January 7, 2010

Subject: Dayco Corporation/L. E. Carpenter Superfund Site
USEPA ID No. NJD002168748
Response to January 6, 2010 MCSCD Comments on the Soil Erosion and Sediment Control Plan, MW-19/Hot Spot 1 Soil Remediation

Dayco Corporation/L. E. Carpenter & Company ~ Borough of Wharton, Morris County, NJ
Master Project Schedule

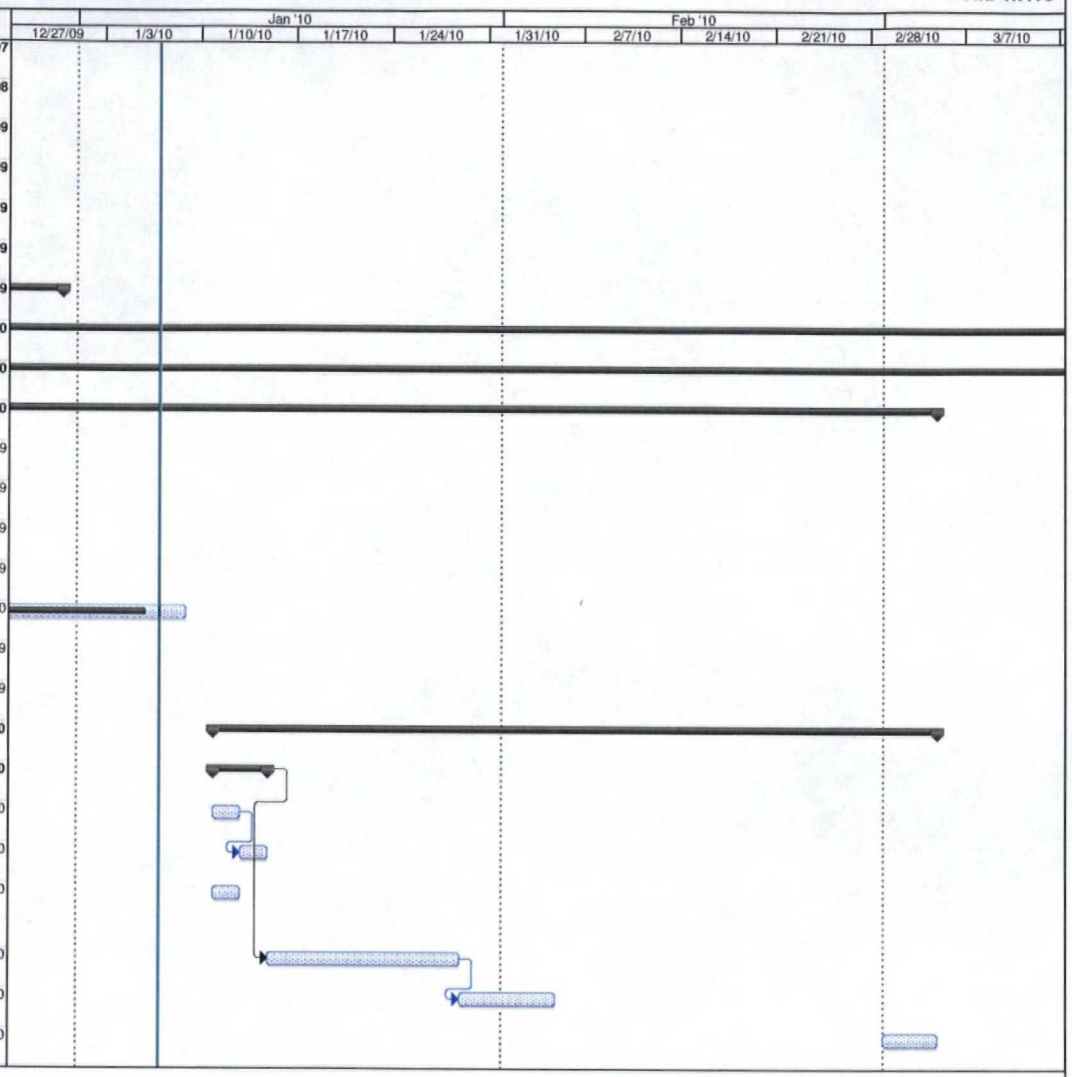
5. ***Provide a calendar for the sequence of construction indicating the installation of conservation practices and the time period within the overall scheme of remediation. (i.e.; Install tracking pad ...day 1, install silt fence ...day 2, permanently stabilize site day 45)***

RMT's Response: A calendar for the construction sequencing for the remediation including the installation of conservation practices has been included as an attachment to this letter.

MW19HS1 CONSTRUCTION SITE LAYOUT

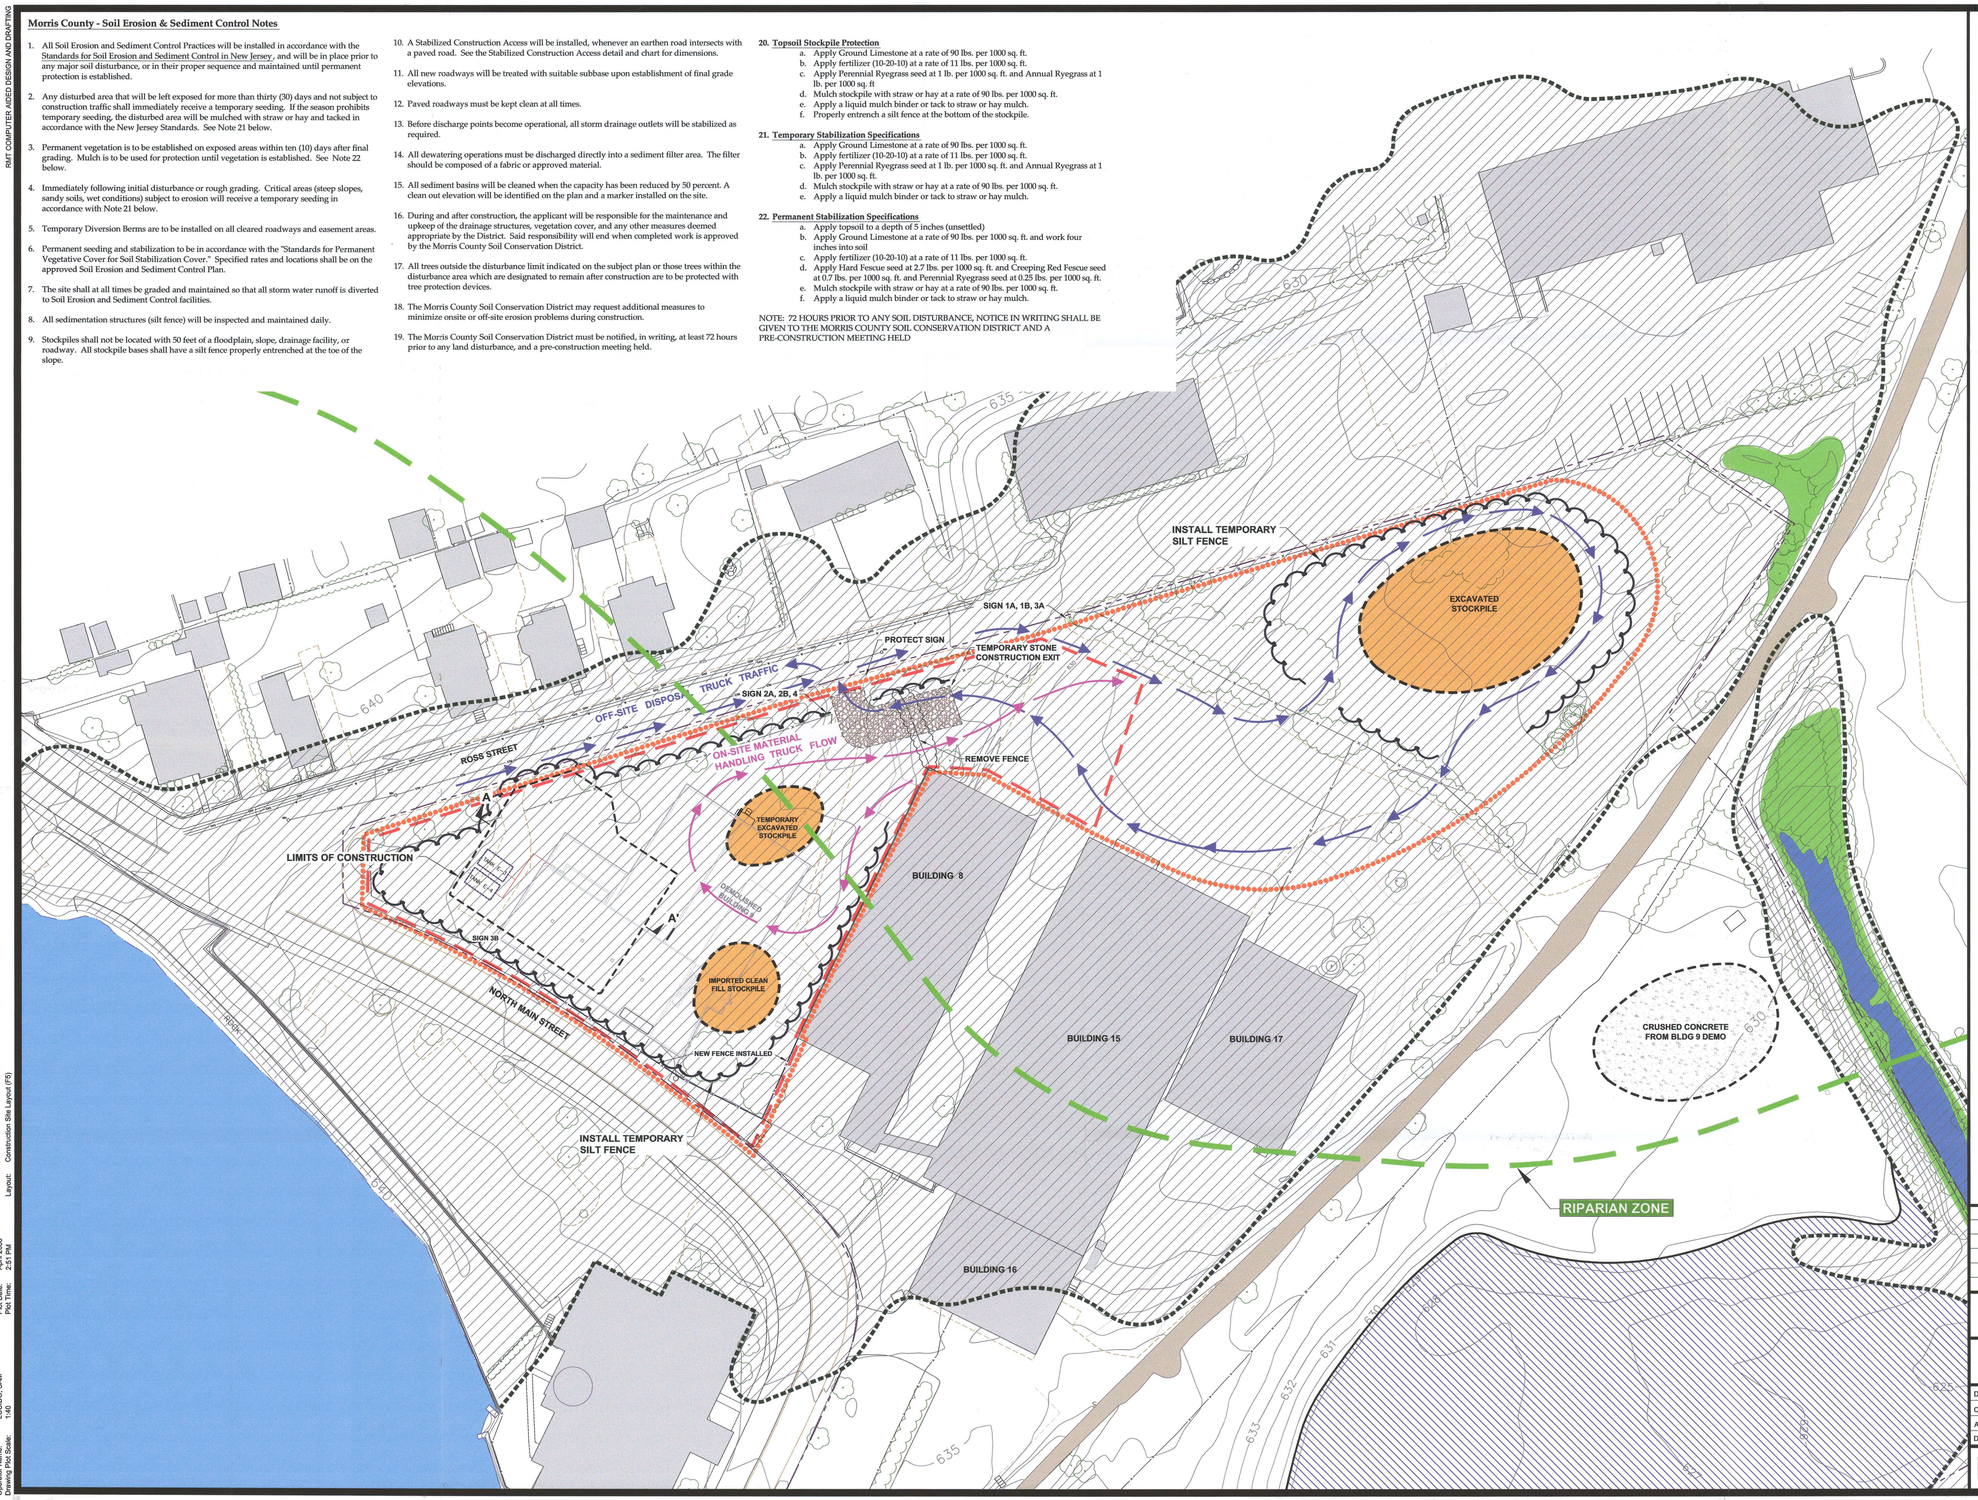
2. ***Close perimeter controls (silt fence) by continuing proposed line along Ross Street to the intersection with proposed egress onto Ross Street.***

3. ***Modify tracking pad alignment/dimension so as to address "off-site disposal truck traffic" and "onsite material handling truck flow" the latter is indicated perpendicular to the pad. The goal is to achieve 50 ft. of interface of traffic.***

RMT's Response: Comment is acknowledged and accepted. Sheet F5 (MW19HS1 Construction Site Layout) has been revised to show the silt fence continuing along Ross Street to the intersection of the temporary construction site entrance/exit. Because of a slight proposed adjustment to the alignment of the temporary construction site entrance/exit with

Ross Street, proposed silt fencing will extend approximately 50 feet to the east of the entrance/exit as shown on Sheet F5 (see response to Comment 3).

RMT's Response: Comment is acknowledged and accepted. Sheet F5 (MW19HS1 Construction Site Layout) has been revised to show the temporary construction site entrance (tracking pad) aligned more parallel to the fence along Ross Street (50-foot length). The "on-site material handling truck flow" path has been modified to show that it will not cross the construction site entrance/exit (tracking pad). This will reduce the amount of sediment accumulation on the tracking pad and potential for sediment to be tracked onto Ross Street.

FINAL GRADE AND END USE PLAN

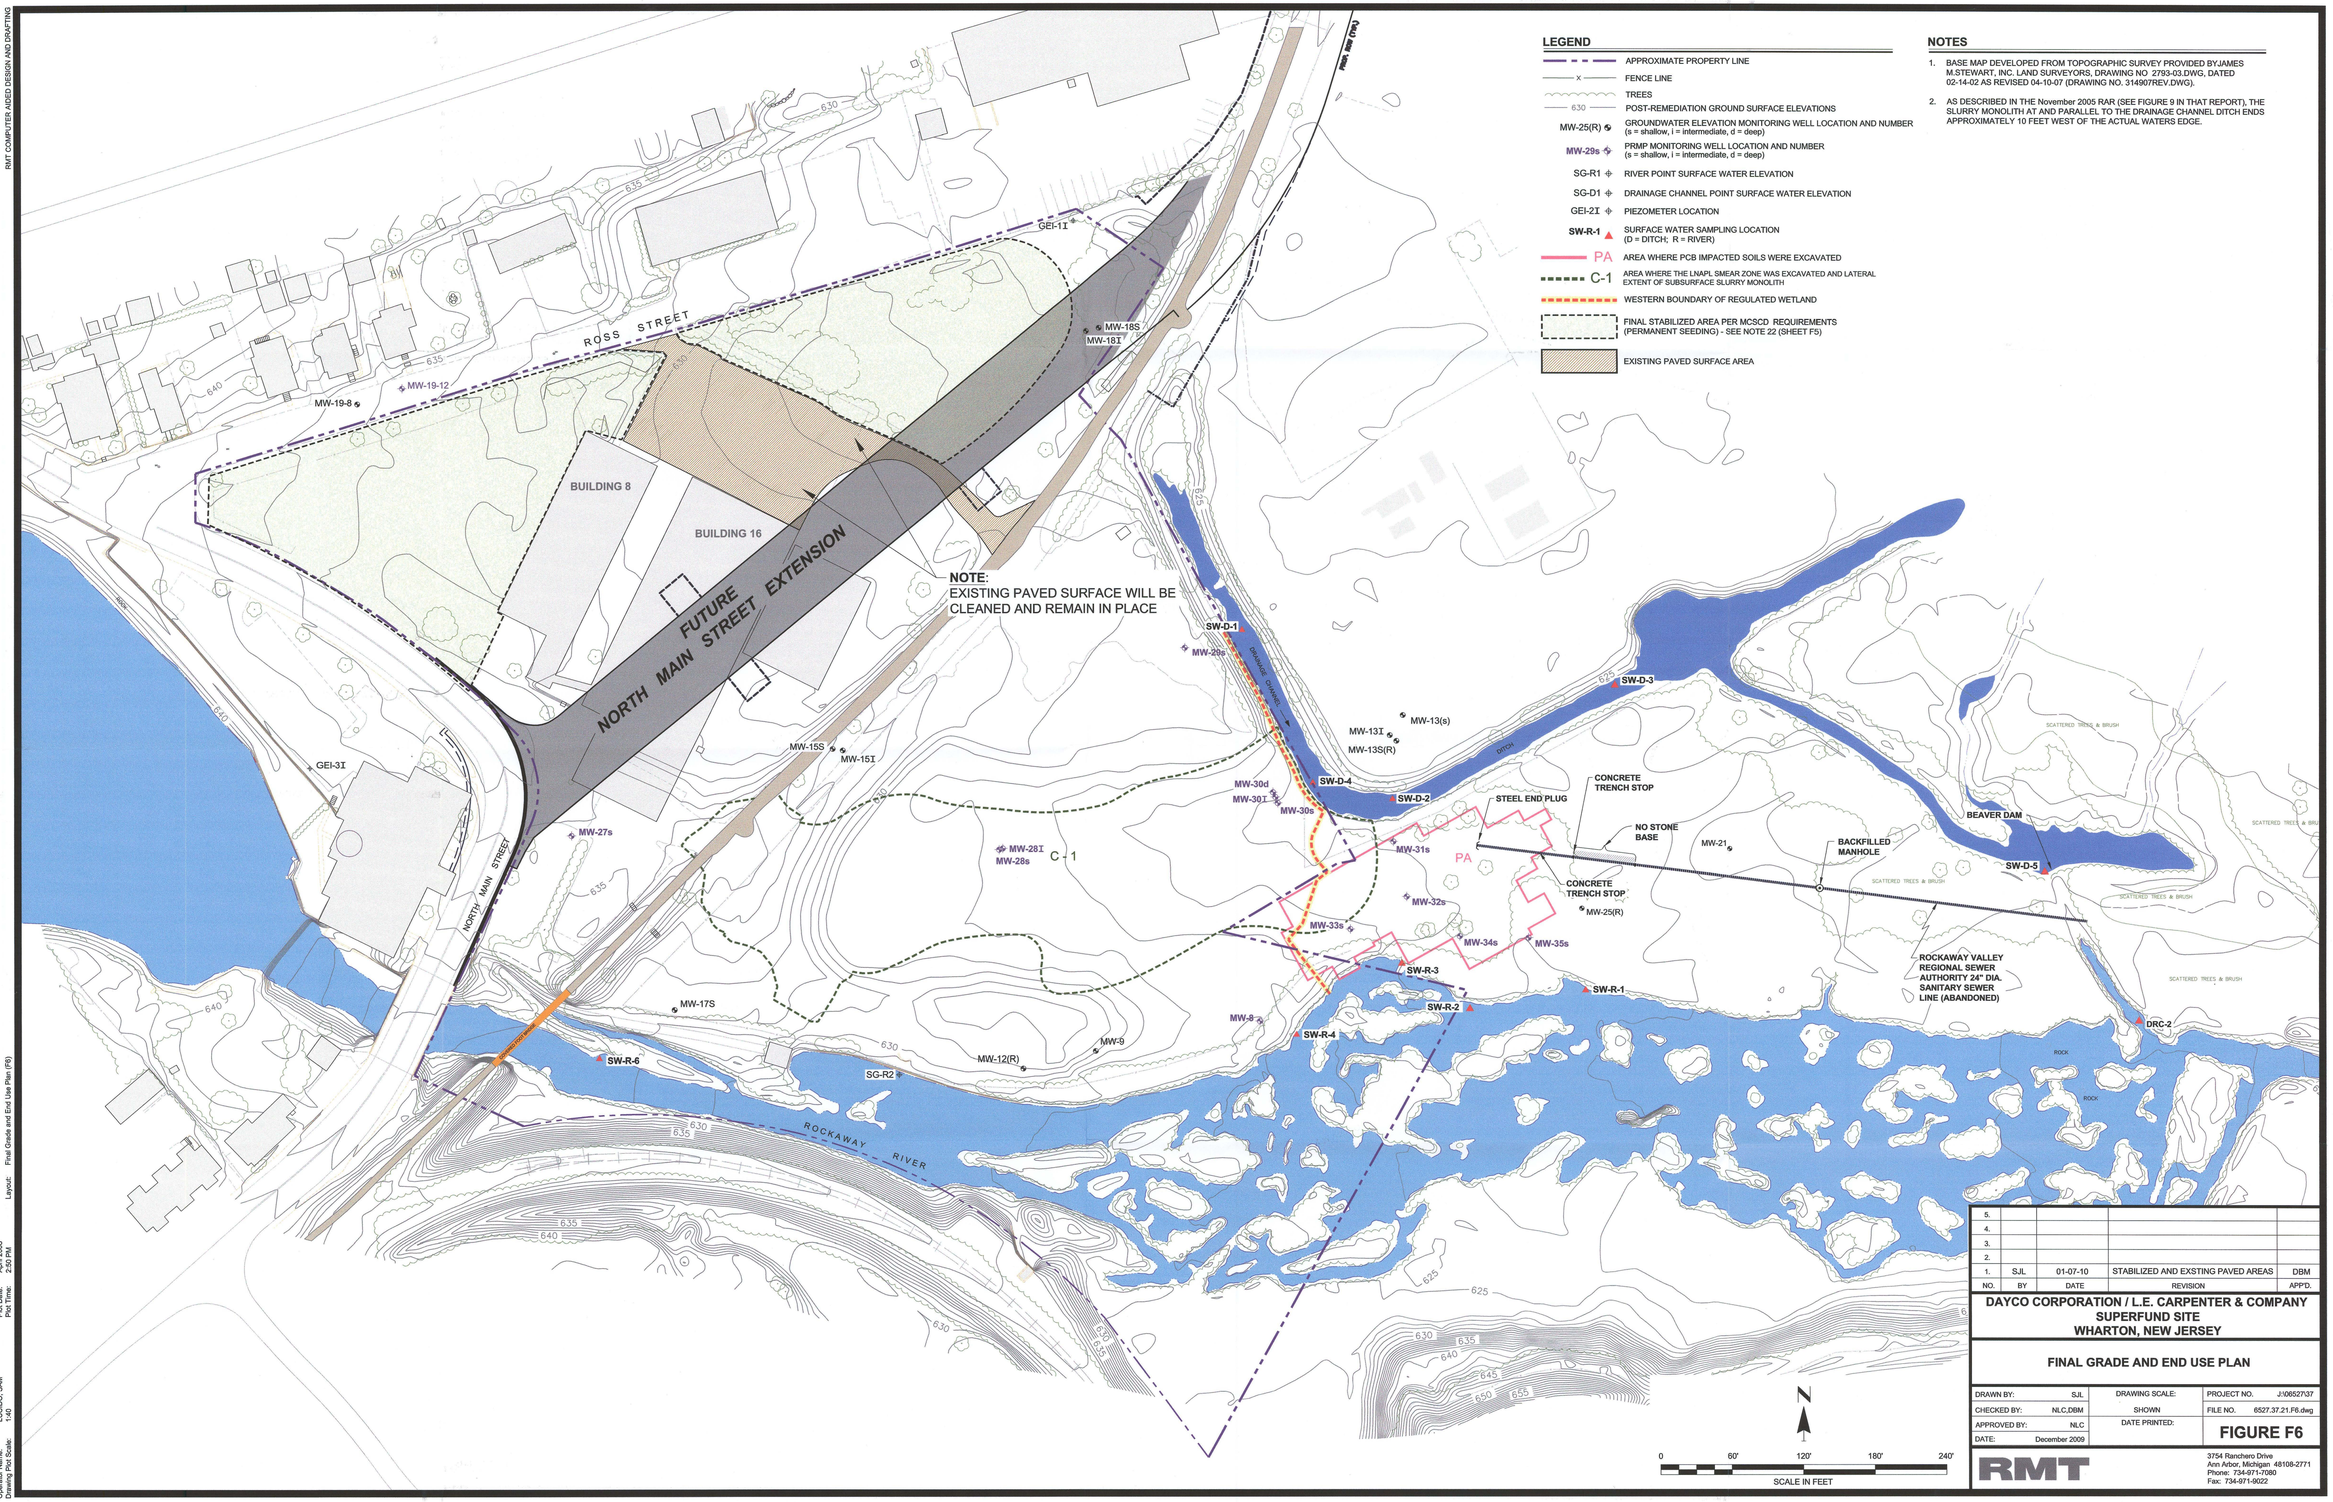
4. ***Provide an explanation for sheet F6 symbol indicating "Final Stabilized Area per NJDEP Requirements (permanent seeding)". This area includes paved parking areas and paved traffic lanes. Does this area require removal of paved surfaces, stabilization, etc. If so, modify perimeter controls (silt fence) to address additional soil disturbance. Explain discrepancies between NJDEP final stabilization on sheet F6 and MCSCD permanent stabilization on Sheet F5.***

RMT's Response: Comment is acknowledged and accepted. Sheet F6 (Final Grade and End Use Plan) has been revised to show only the current vegetated areas and area within the Building 9 demolition/limits of construction) being stabilized per MCSCD permanent stabilization requirements. The existing paved surface immediately North of Building 8 and Building 16 will not be removed as part of the remedial construction. Any accumulated sediment on this paved surface will be properly cleaned during and at the conclusion of all remedial activities.

Sheet F6 has been revised to reference the MCSCD permanent stabilization requirements outlined on Sheet F5.

SEDIMENT CONTROL (SILT) FENCE

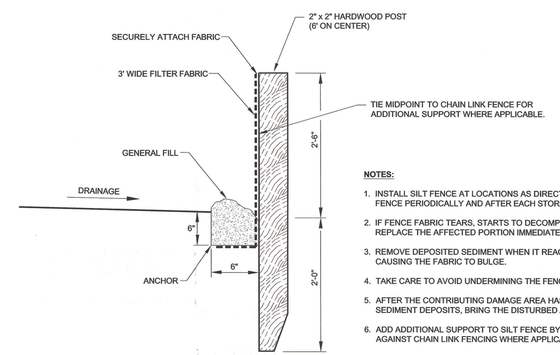
1. ***Place note on silt fence detail to include additional support by tying midpoints of silt fence against chain link fencing when applicable.***

RMT's Response: Comment is acknowledged and accepted. Sheet F7 (MW19HS1 Construction Details) has been revised to reflect the change to the silt fence detail.
